1 ADDENDUM #4

Issued for Addendum #4

Project Title:
Holland College Summerside
Waterfront Campus - GreenBuild
Trade Expansion

Drawing Number:
ASK007

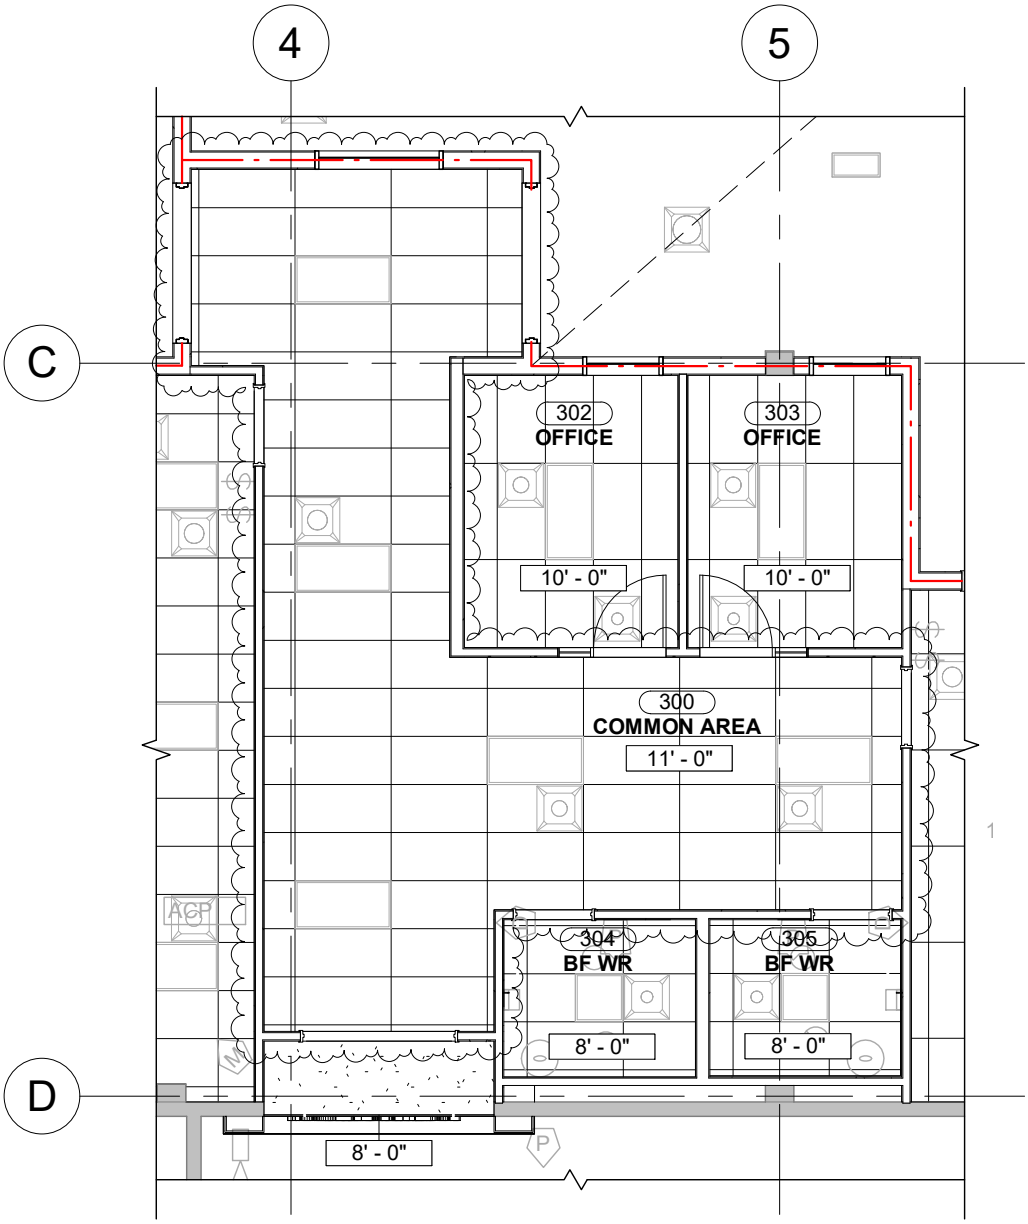
.2 Reference detail 2/A160 main level RCP:

.1 Revise common area 300 reflected ceiling plan to ASK007.

1
ASK008

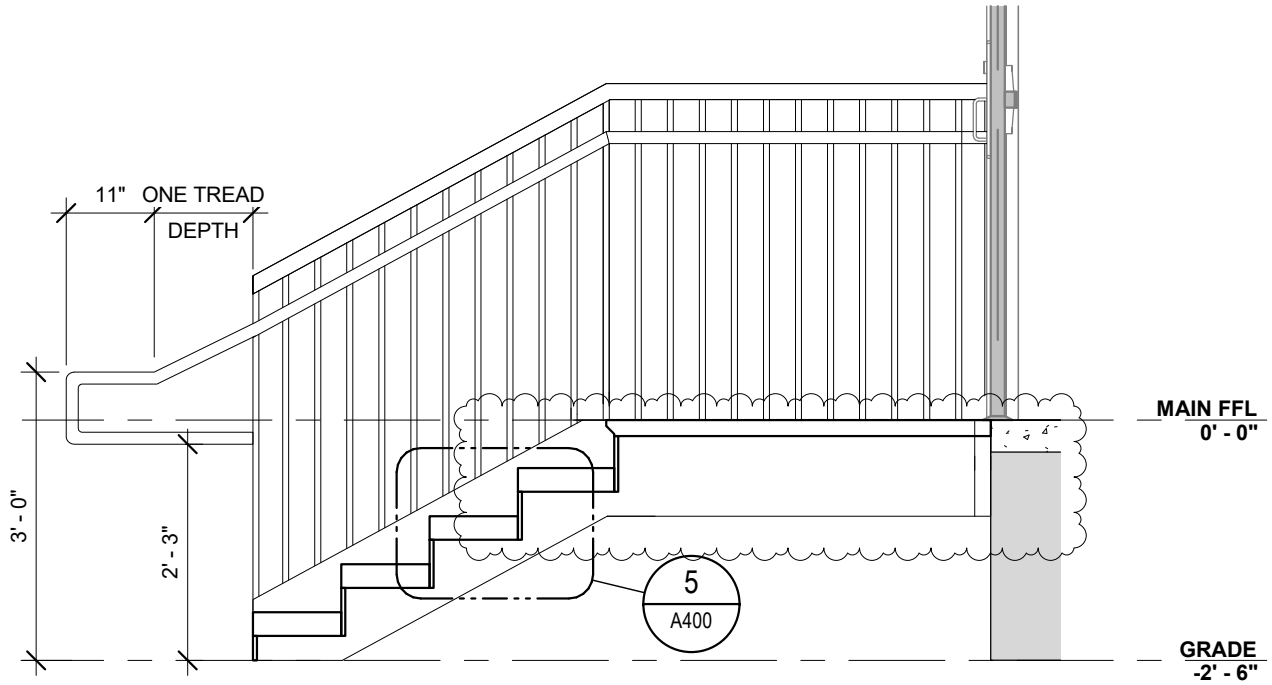
.1 Reference detail 2/A400 stair 01 - section:

.1 Delete and replace with detail 1/ASK008.

NOTE: RAISE THE STAIR STRUCTURE TO ELIMINATE THE EXISTING 3″ ELEVATION DIFFERENCE BETWEEN THE TOP OF THE LANDING AND THE MAIN FLOOR. SET THE TOP OF THE LANDING FLUSH WITH THE EXISTING FINISHED MAIN FLOOR AND ALIGN THE NEW DOOR THRESHOLD WITH THIS ELEVATION.

2
ASK008

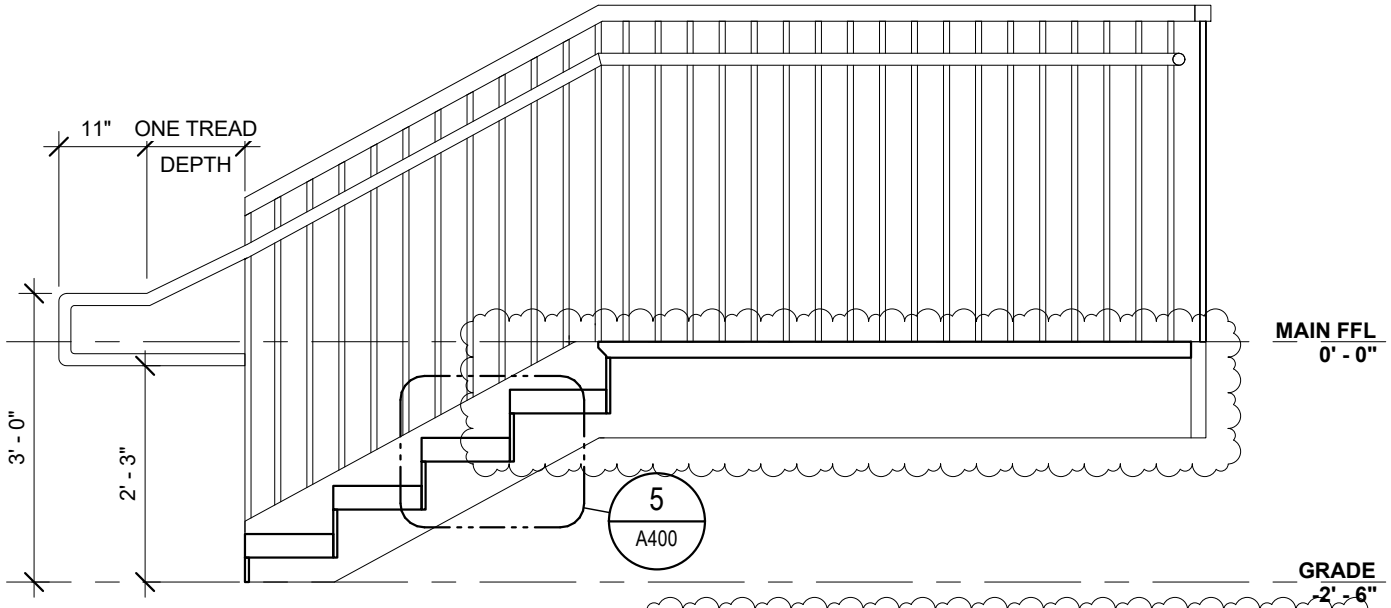
.2 Reference detail 4/A400 stair 01 - section:

.1 Delete and replace with detail 2/ASK008.

NOTE: RAISE THE STAIR STRUCTURE TO ELIMINATE THE EXISTING 3″ ELEVATION DIFFERENCE BETWEEN THE TOP OF THE LANDING AND THE MAIN FLOOR. SET THE TOP OF THE LANDING FLUSH WITH THE EXISTING FINISHED MAIN FLOOR AND ALIGN THE NEW DOOR THRESHOLD WITH THIS ELEVATION.

Drawing Number:
ASK009

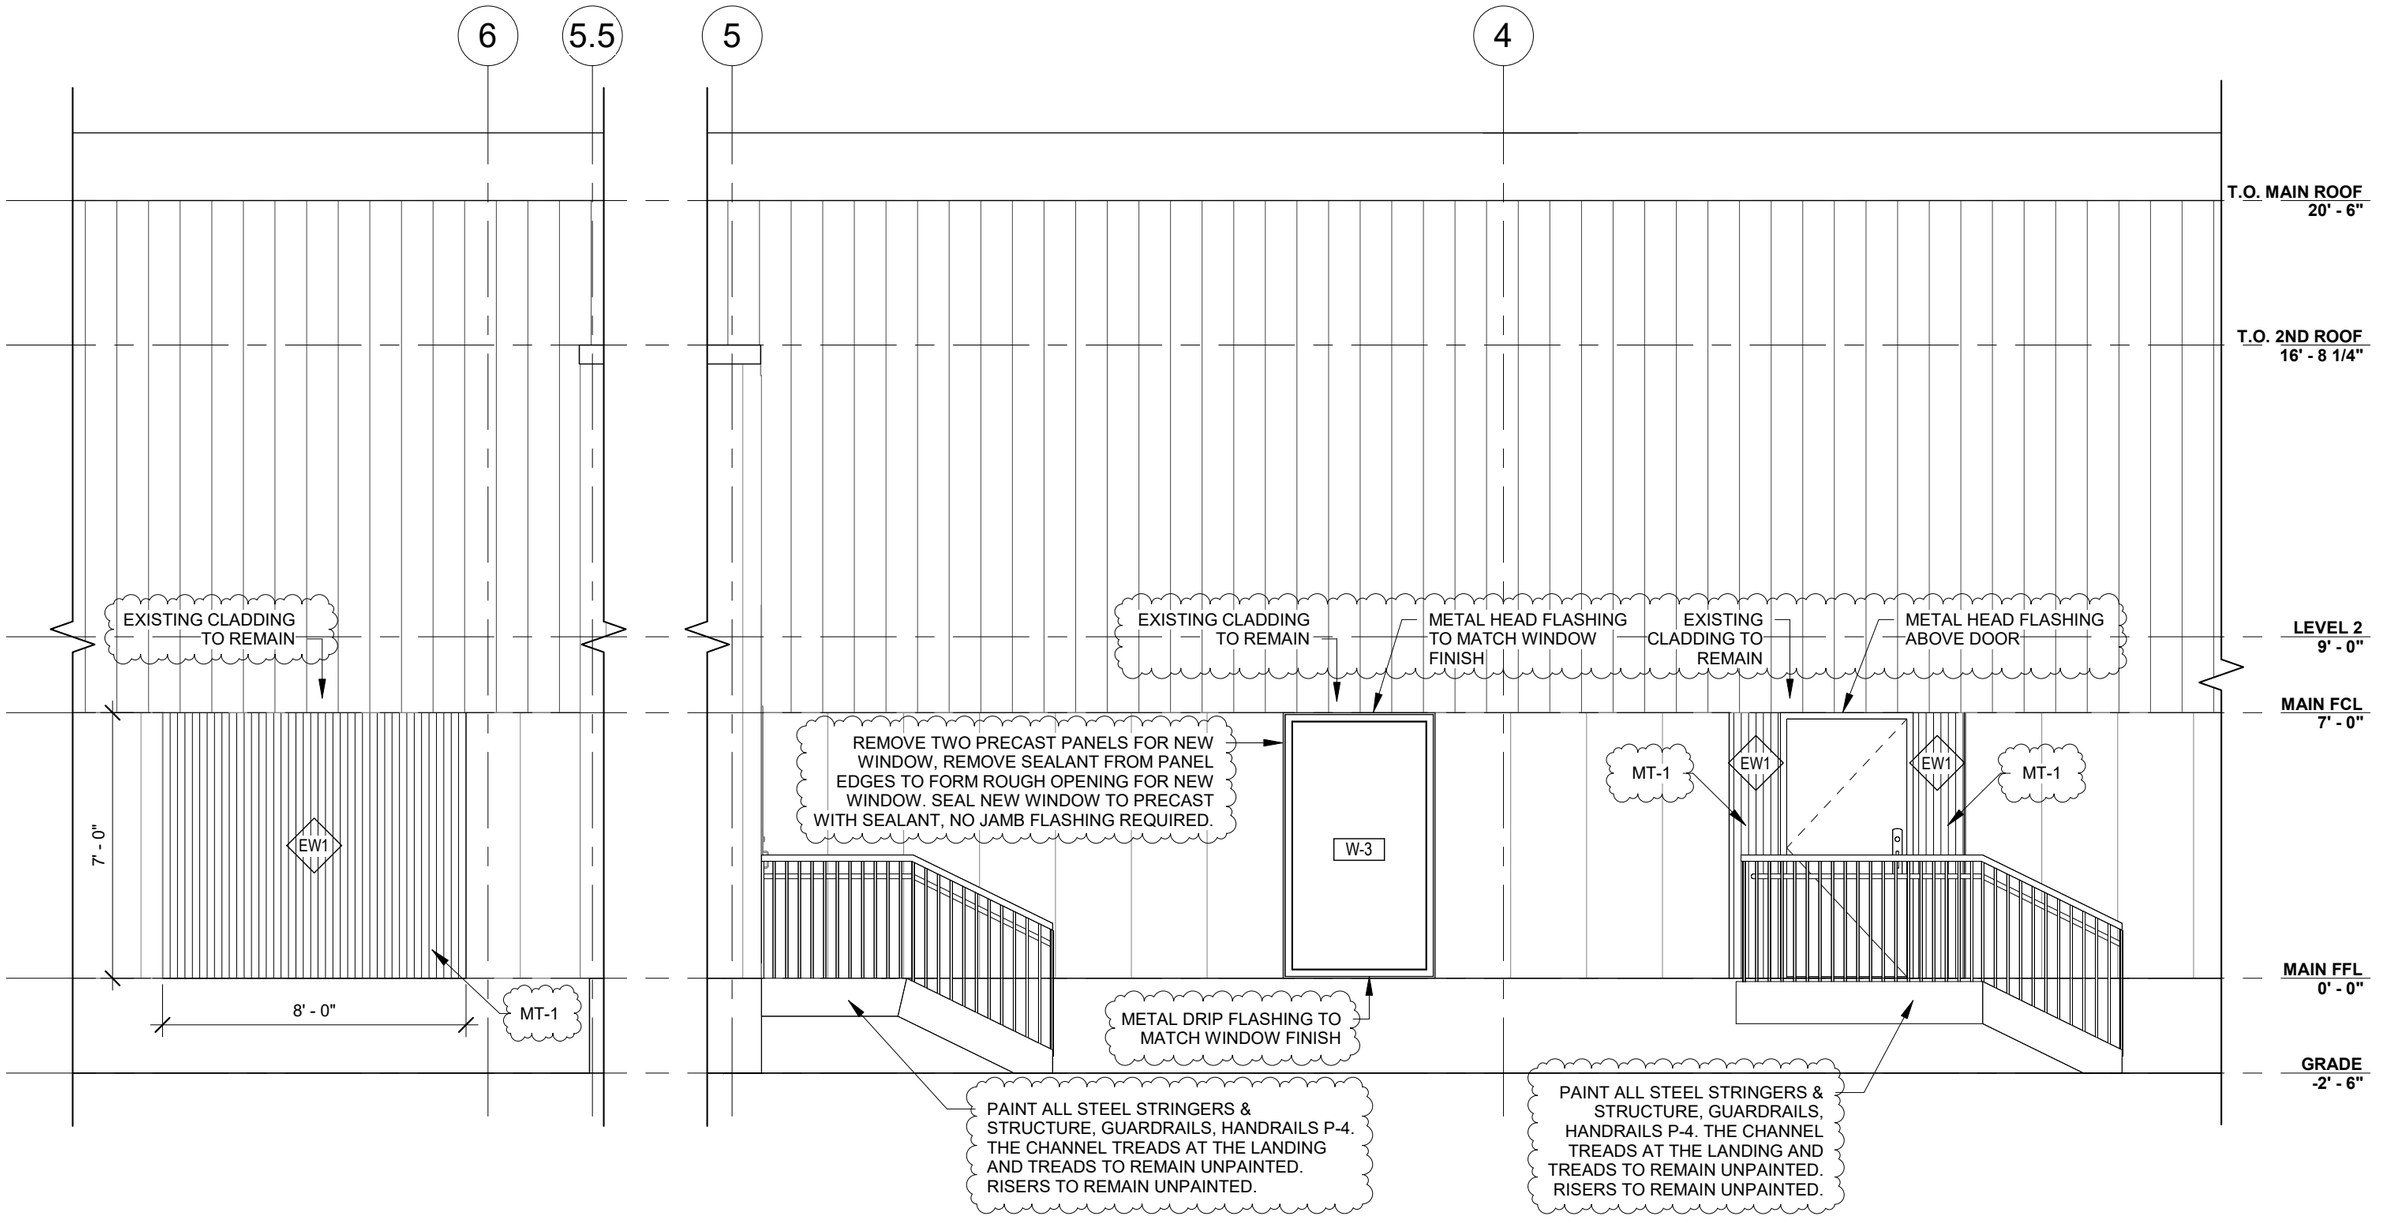
.1 Reference detail 1/A250 ELEVATION 1:

.1 Delete and replace with ASK009.

1 MSK009 — Revised Supply/ Return Diffuser Layout for Classroom 301 and Common Area 300

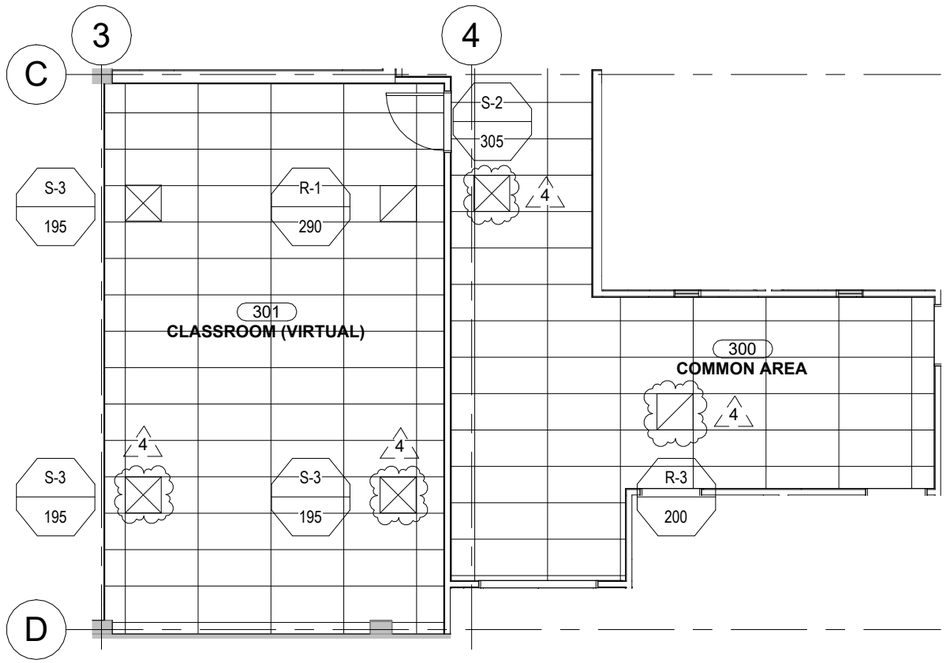
.1 Reference Classroom 301 and Common Area 300 areas:

.1 Revise supply diffuser and return grille locations as shown on Detail 1/MSK009. Common Area 300 diffusers and grilles relocated to suit new lay-in T-bar ceiling grid.

2 MSK009 — Revised Exhaust Diffuser Layout for Common Area 300

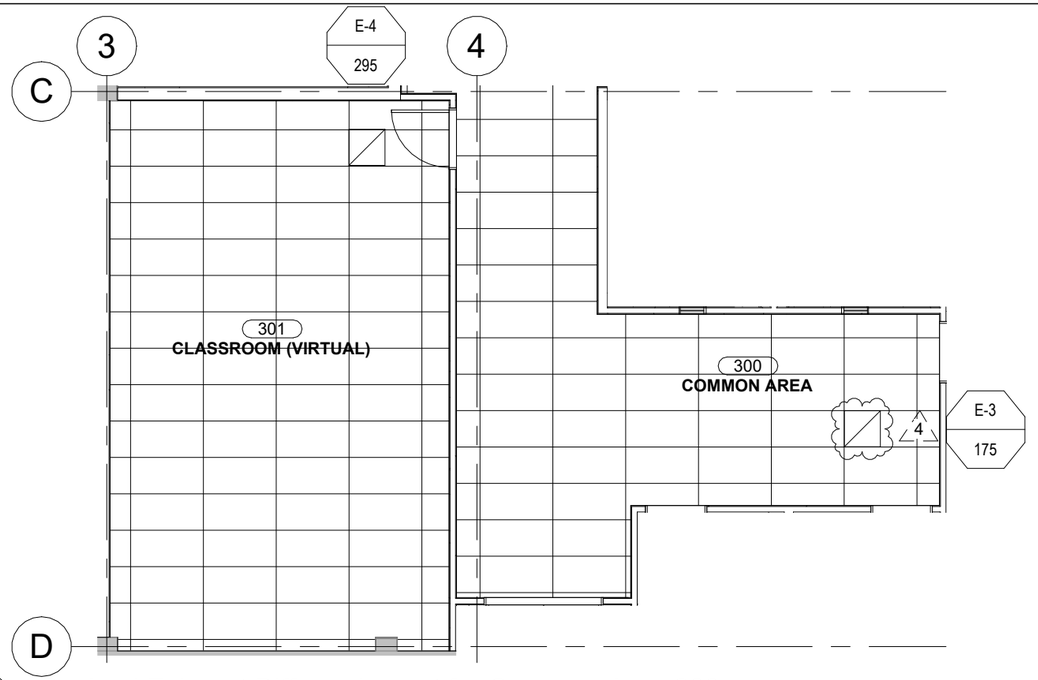
.1 Reference Common Area 300:

.1 Revise exhaust grille location as shown on Detail 2/MSK009.

Drawing Number:
ESK001

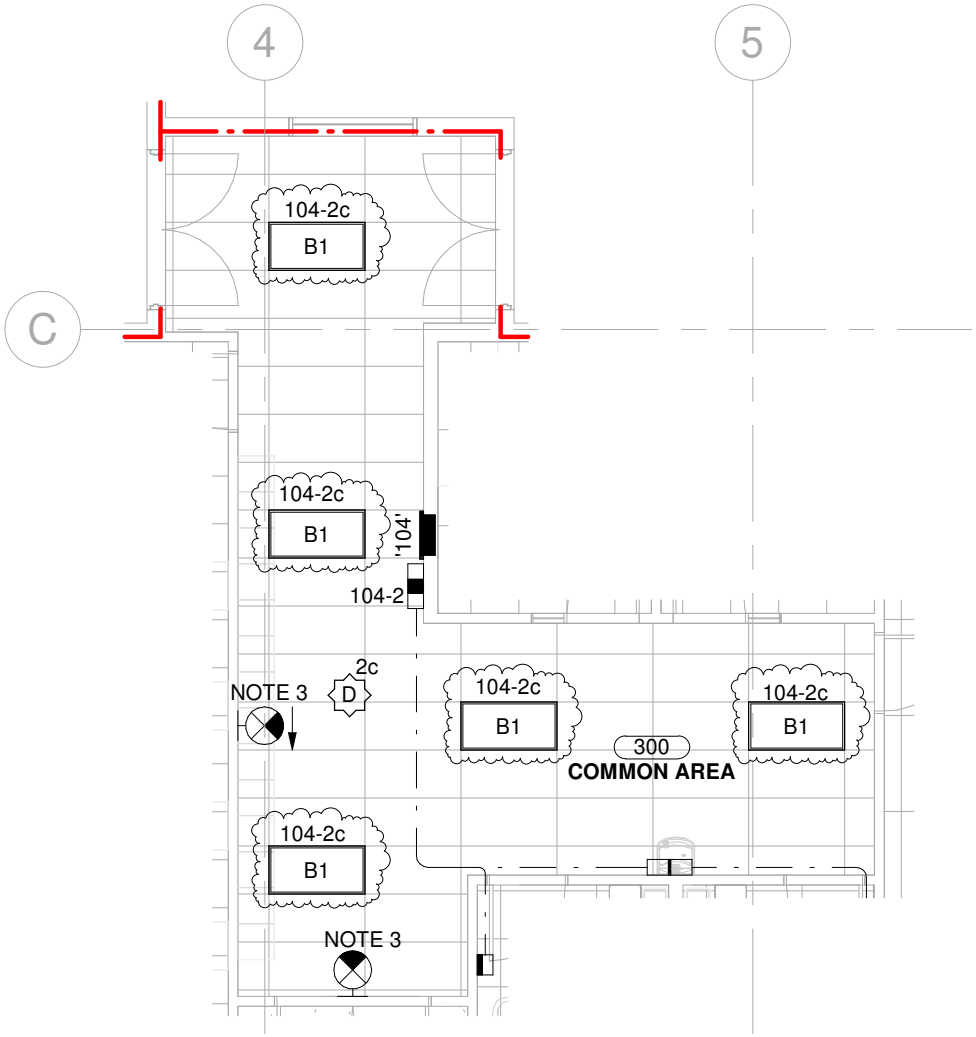
.1 Type C3 luminaires in Common Area 300 are to be changed to Type B1 luminaires. Reference Sketch ESK001 attached and forming part of this addendum for additional information on new lighting layout.
